HARTZELL PROPELLER INC.
SERVICE BULLETIN
TRANSMITTAL SHEET
HC-SB-61-311

Propeller - Replacement of 835-54(P) Spinner Assembly

December 13, 2011

This page transmits a revision to Service Bulletin HC-SB-61-311.

**Cut-away View of the 103585() Spinner Assembly
Figure 3**

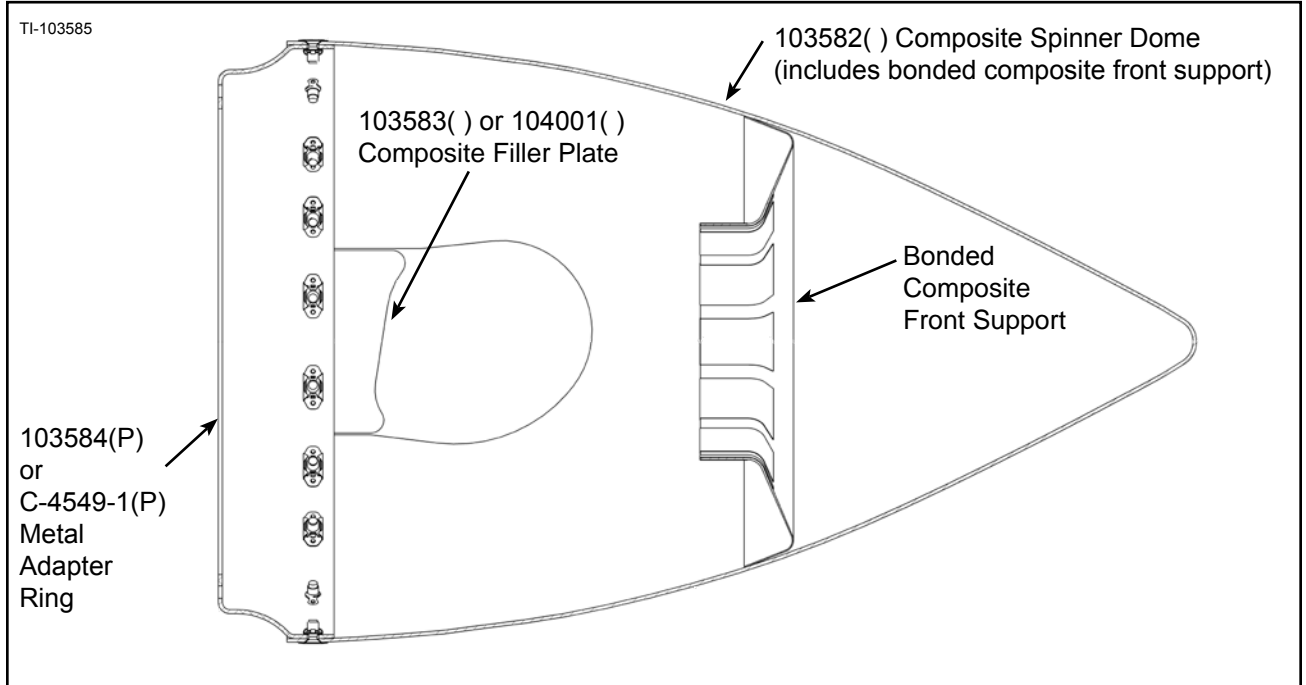
- (a) The 835-54(P) spinner assembly will no longer be manufactured and will not be procurable through Hartzell Propeller.
- (6) Revision 2 of this Service Bulletin introduced the new 103585() spinner assembly as a supersedure to the 835-54(P) spinner assembly in approved applications. Refer to Figure 3.

- (a) The 103585() spinner assembly includes a 103582() composite spinner dome with bonded front support, the 103583() or 104001() composite filler plates, and a 103584P metal adapter ring with assembly hardware.
- (b) The C-4549-1(P) metal adapter ring, originally supplied with the 835-54(P) spinner assembly can be used in accordance with this Service Bulletin as an alternate to the 103584P metal adapter ring as a component of the 103585() spinner assembly.
 - 1 When the C-4549-1(P) metal adapter ring is used in the 103585() spinner assembly, installation of the 103583() or 104001() composite filler plates is optional, but requires modification in accordance with the Accomplishment Instructions in this Service Bulletin.

**Cut-away View of the 835-58(P) Spinner Assembly
Figure 4**

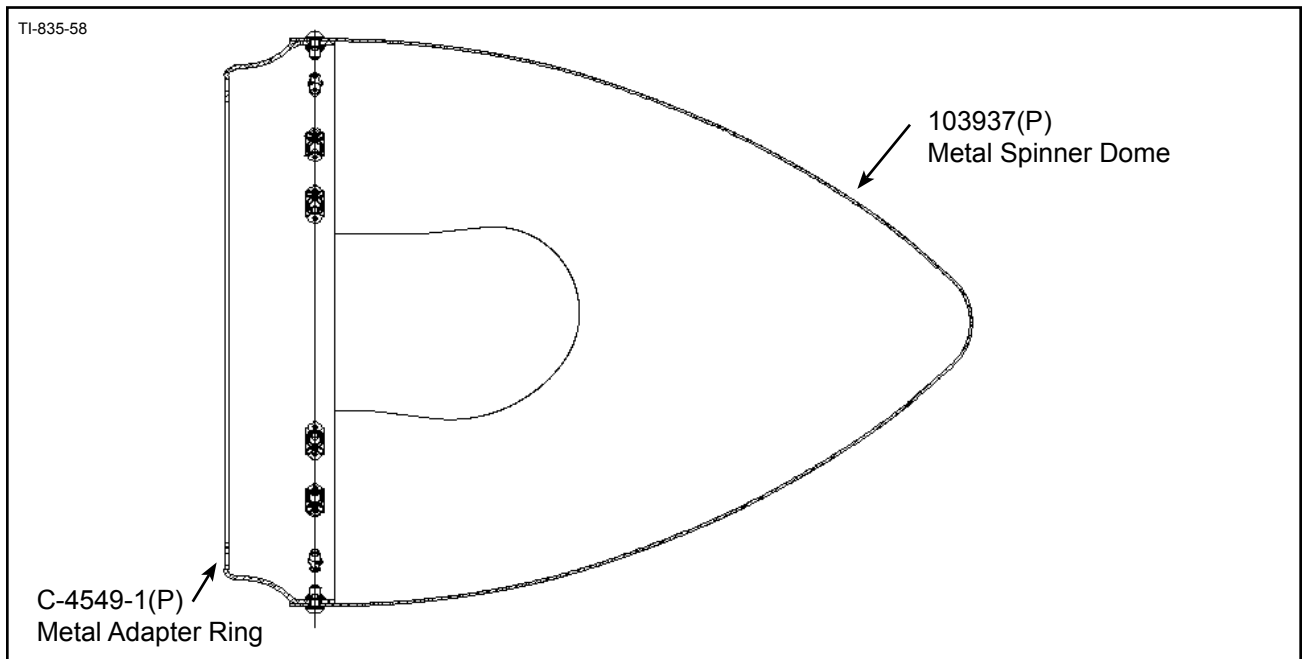
- (7) Revision 2 of this Service Bulletin introduced the new 835-58(P) spinner assembly as a supersedure to the 835-54(P) spinner assembly in approved applications. Refer to Figure 4.

- (a) The 835-58(P) spinner assembly includes the new 103937(P) metal spinner dome and the C-4549-1(P) metal adapter ring with assembly hardware.

- (8) Revision 2 of this Service Bulletin clarified that the existing 835-33(P) spinner assembly is an approved spinner option for the approved applications. The shape of the 835-58(P) spinner assembly is the same as the shape of the 835-33(P) spinner assembly. Refer to Figure 4.

103584(P) or Modified C-4549-1(P) Metal Adapter Ring
Figure 7

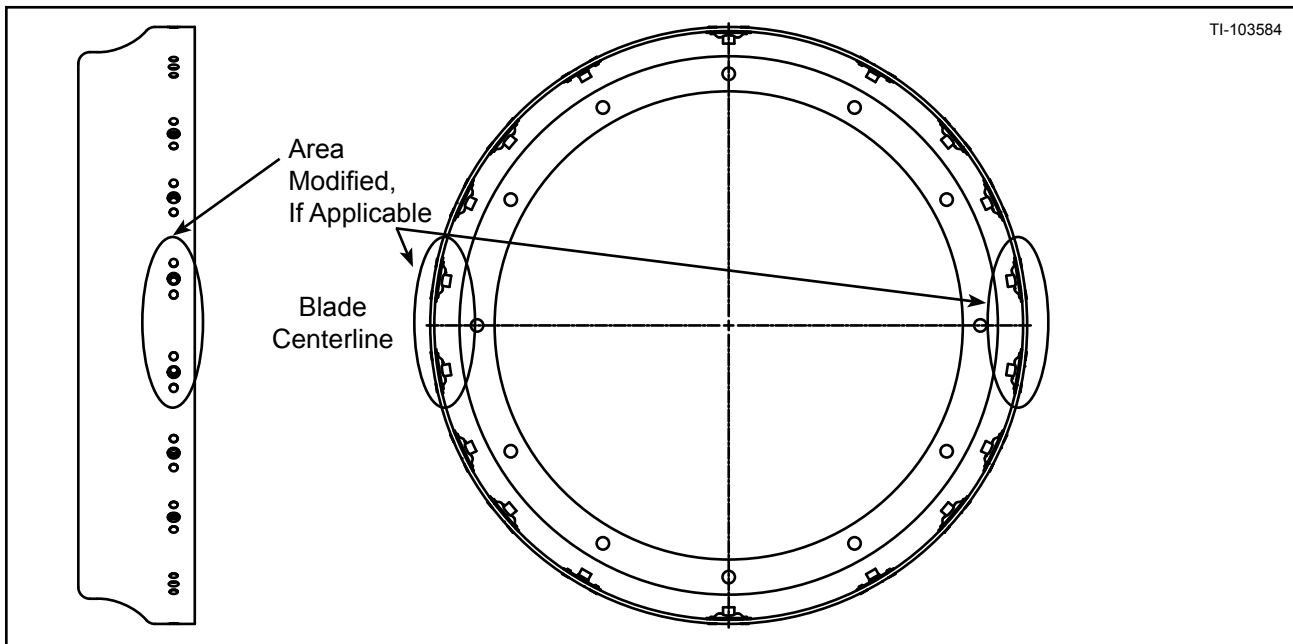
- 2 If the 103583() or 104001() composite filler plates will be installed with the C-4549-1(P) metal adapter ring, modification of the adapter ring is required in accordance with the Accomplishment Instructions of this Service Bulletin. Refer to Figure 6 and Figure 7.

NOTE: A C-4549-1(P) metal adapter ring can be modified into the 103584(P) metal adapter ring in accordance with this Service Bulletin. This configuration is approved for the 103585() spinner assembly in accordance with this Service Bulletin. The 103585() spinner assembly is only available for purchase from Hartzell with the 103584P (polished) metal adapter ring.

- (i) On the inside diameter of the C-4549-1(P) metal adapter ring, hold one (1) B-3849-3 floating nutplate so that the nutplate is oriented in the same direction as the other nutplates on the inner diameter of the adapter ring and the filler plate attachment hole is aligned with the other assembly holes and with the newly drilled hole. Refer to Figure 6, Figure 7, and Figure 8.

Installation of the 103583() or 104001() Composite Filler Plates on the 103585() Spinner Assembly
Figure 8

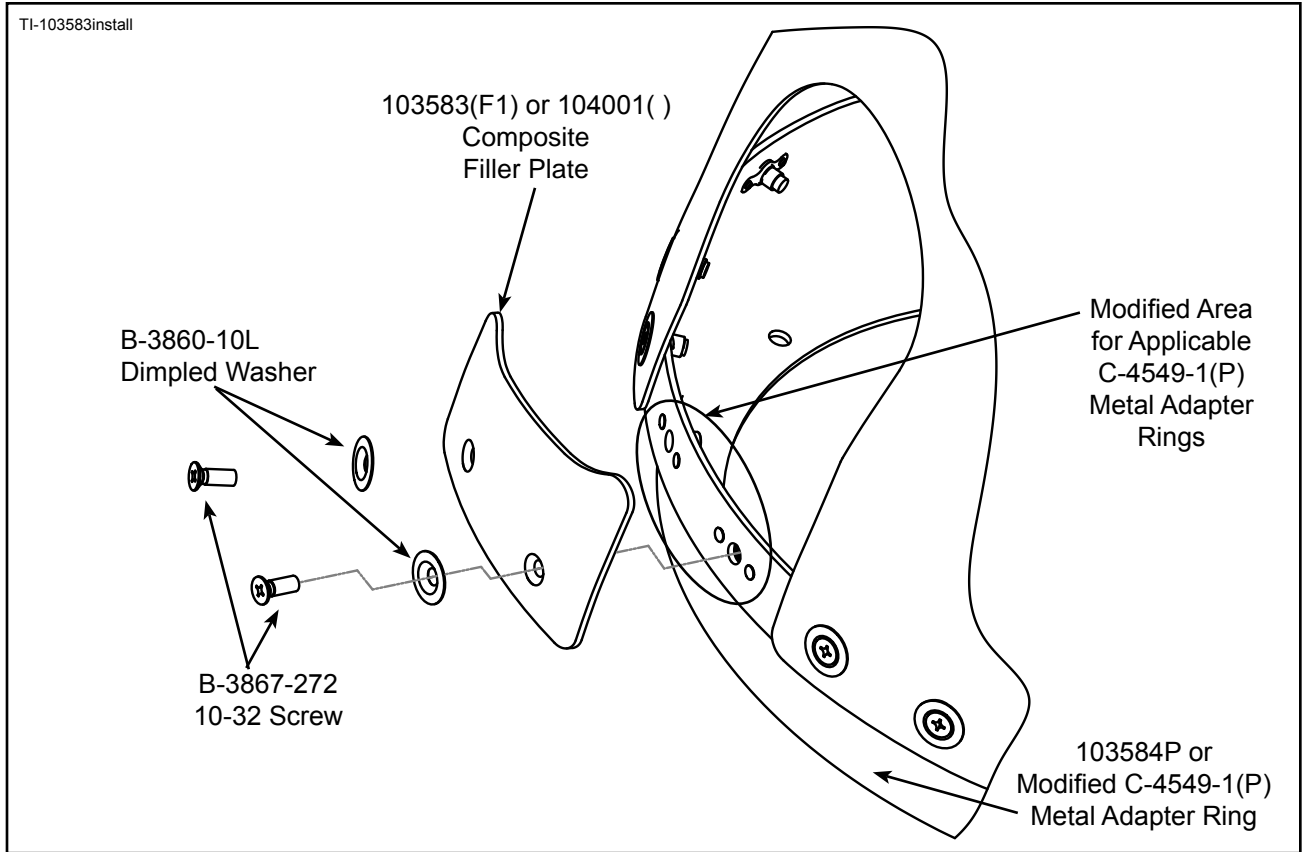
- (d) Hold one of the 103583() or 104001() composite filler plates in place, centered in one of the blade cut-out holes, flush with the bottom edge of the adapter ring, aligning the filler plate attachment holes with the row of assembly screws around the dome. Refer to Figure 6 and Figure 8.
